**ISO/IEC/IEEE
8802-1AE**

**Part 1AE:
Media access control (MAC) security**

**AMENDMENT 4: MAC Privacy
Protection**

Reference number
ISO/IEC/IEEE 8802-1AE:2020/
Amd.4:2024(en)

Figure 10-5—SecY managed objects

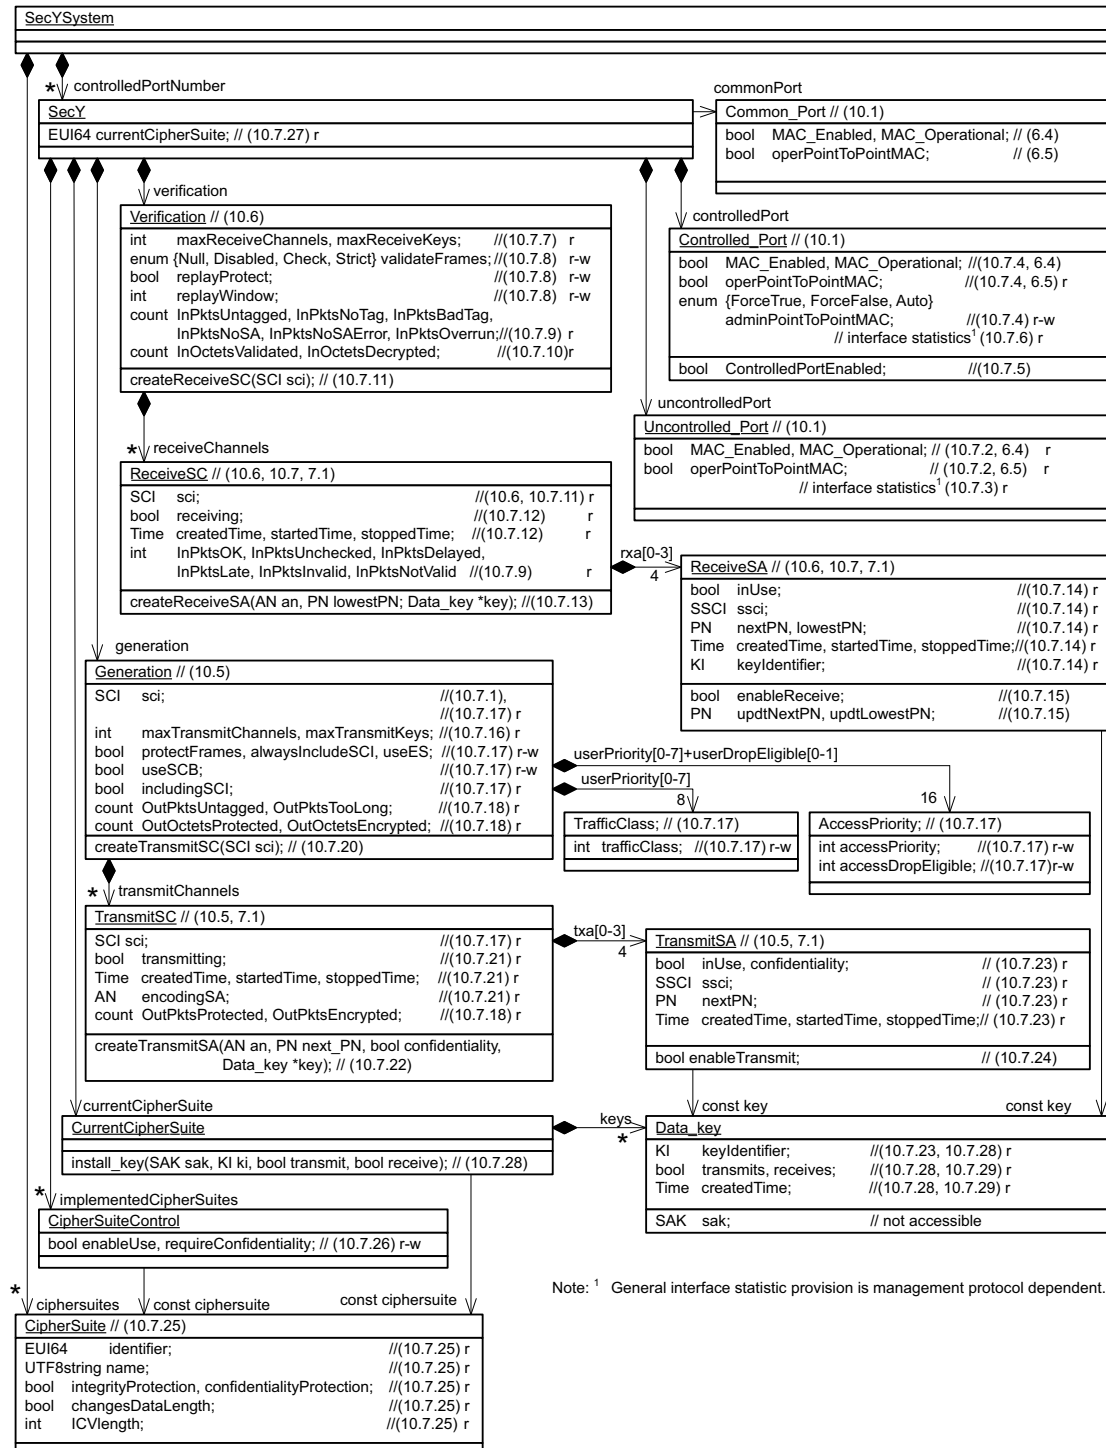
NOTE 2—Figure 10-5 was revised by IEEE Std 802.1AE-2022 to provide cross-references and to indicate the accessibility, read (r) or write (w) status of parameters that can be managed by remote management protocol, as specified for the SecY MIB module (Clause 13) or the YANG module (Clause 23). Whether access to particular management parameters is permitted is also subject to security considerations, as described for each of those modules.

Replace Figure 10-5 with the following figure:
